# ENDL TEXAS

Date: 19 July 2008  
 To: T10 Technical Committee  
 From: Ralph O. Weber  
 Subject: OSD-2 Snapshots and related enhancements

## Change 1 – Snapshots and Clones

**Figure x1 — Snapshot history chain after first CREATE SNAPSHOT command**

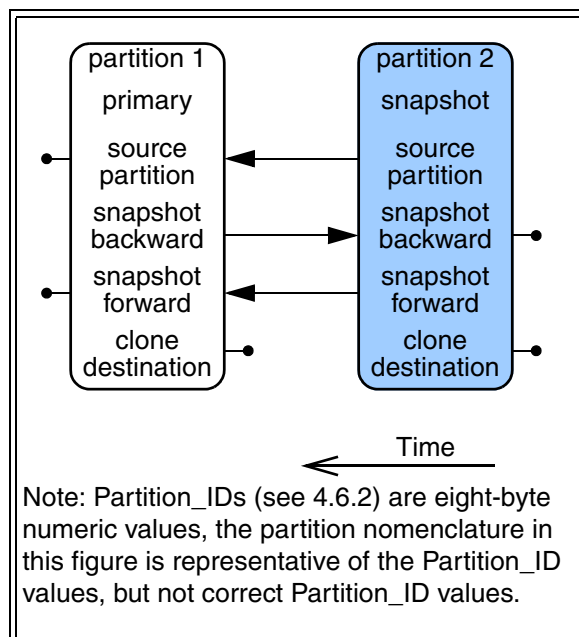
Figure x1 shows the history chain for a primary partition with a single snapshot. The conditions show in figure x1 would be present after a CREATE SNAPSHOT command (see 6.e) with partition 1 as the source partition and partition 2 as the destination. Since the contents of snapshot is fixed in time while the primary partition continues to evolve, time might be viewed as flowing in the direction of the arrow.

The attributes in the Snapshots Information attributes page (see 7.1.2.e) that maintain the history chain for figure x1 are summarized in table x201.

**Figure x2 — Snapshot history chain after second CREATE SNAPSHOT command**

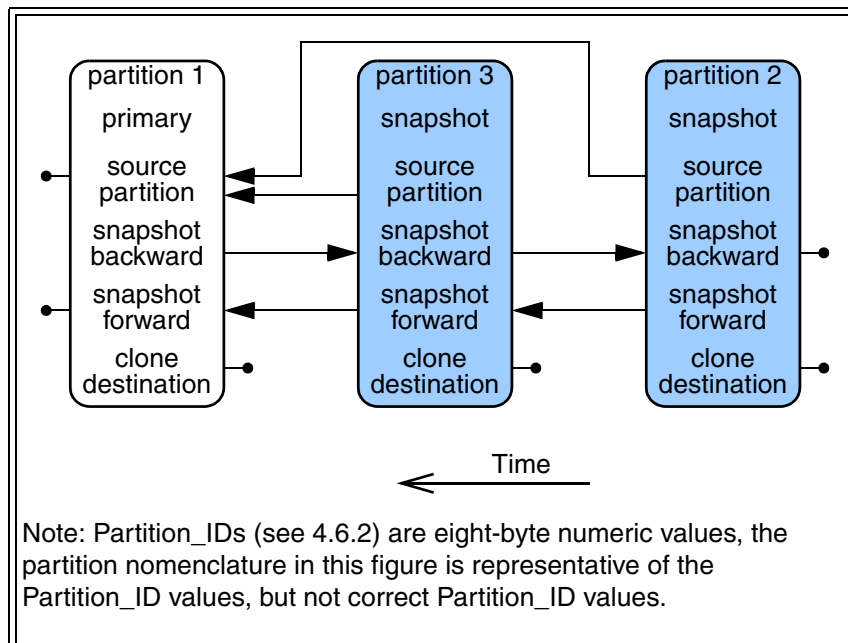
If a second snapshot is taken at a later time, the history chain would become as shown in figure x2.

The attributes in the Snapshots Information attributes page (see 7.1.2.e) that maintain the history chain for figure x2 are summarized in table x202.

**Figure x3 — Snapshot/clone chains after a first CREATE CLONE command**

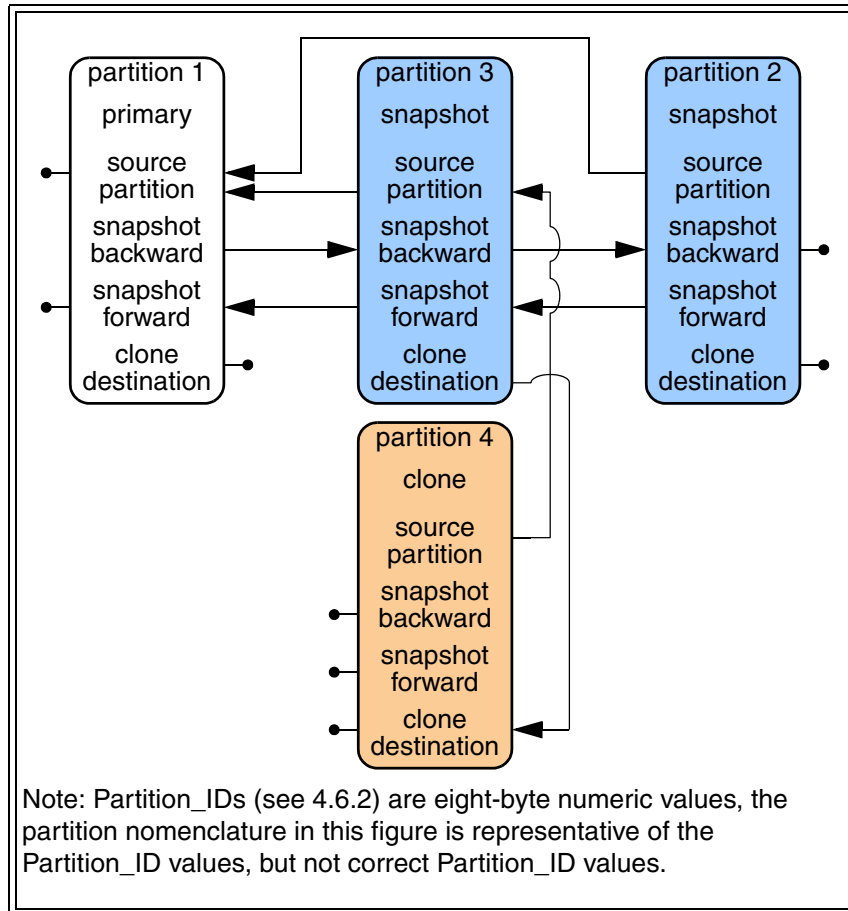
Figure x3 builds on figure x2 (see 4.d.2.2) to show the effects of a CREATE CLONE command (see 6.d) with partition 3 as the source partition and partition 4 as the destination.

The attributes in the Snapshots Information attributes page (see 7.1.2.e) that maintain the clone chain for figure x3 are summarized in table x203.

Figure x4 — Snapshot/clone chains after a second CREATE CLONE command

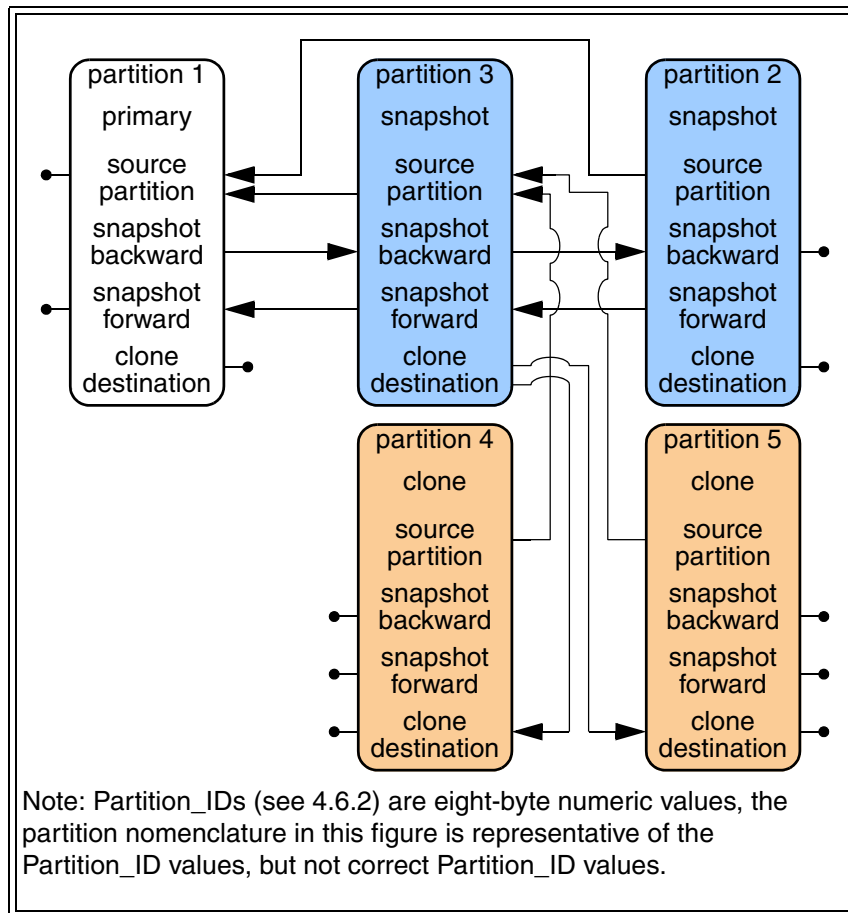
The effects of a second CREATE CLONE command (see 6.d) with partition 3 as the source are shown in figure x4.

The attributes in the Snapshots Information attributes page (see 7.1.2.e) that maintain the clone chain for figure x4 are summarized in table x204.

**Figure x5 — Snapshot/clone chains after a CREATE SNAPSHOT command on a clone partition**

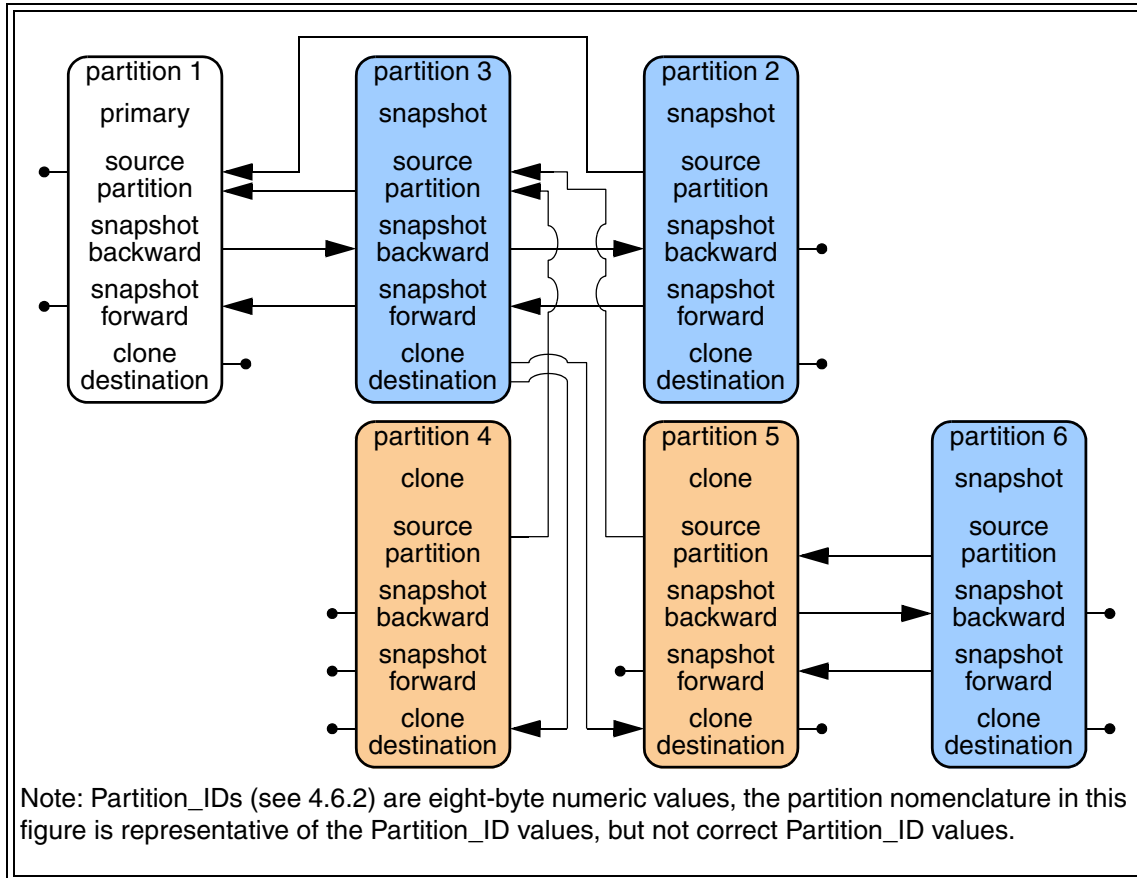
A clone partition may be specified as the source partition for a CREATE SNAPSHOT command (see 6.e). Figure x5 builds on figure x4 (see 4.d.2.3) to show the effects of a CREATE SHAPSHOT command with clone partition 5 as the source partition and partition 6 as the destination.

The attributes in the Snapshots Information attributes page (see 7.1.2.e) that maintain the new history chain in figure x5 are summarized in table x205.

**Figure x6 — Snapshot/clone chains after a DETACH CLONE command**

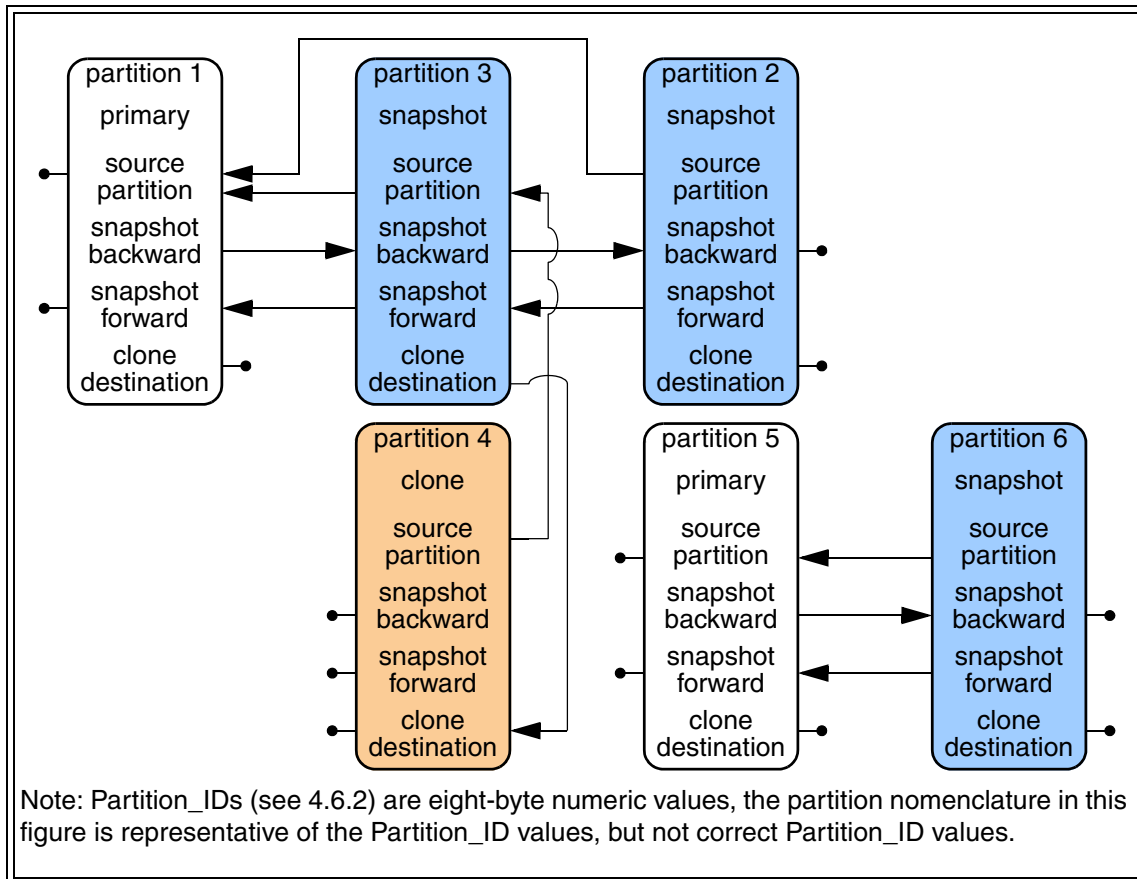
A clone partition may be detached from its source partition using a DETACH CLONE command (see 6.f). Figure x6 builds on figure x5 (see 4.d.2.4) to show the effects of a DETACH CLONE command for partition 5.

The attributes in the Snapshots Information attributes page (see 7.1.2.e) that maintain the two history chains shown in figure x6 are summarized in table x206.
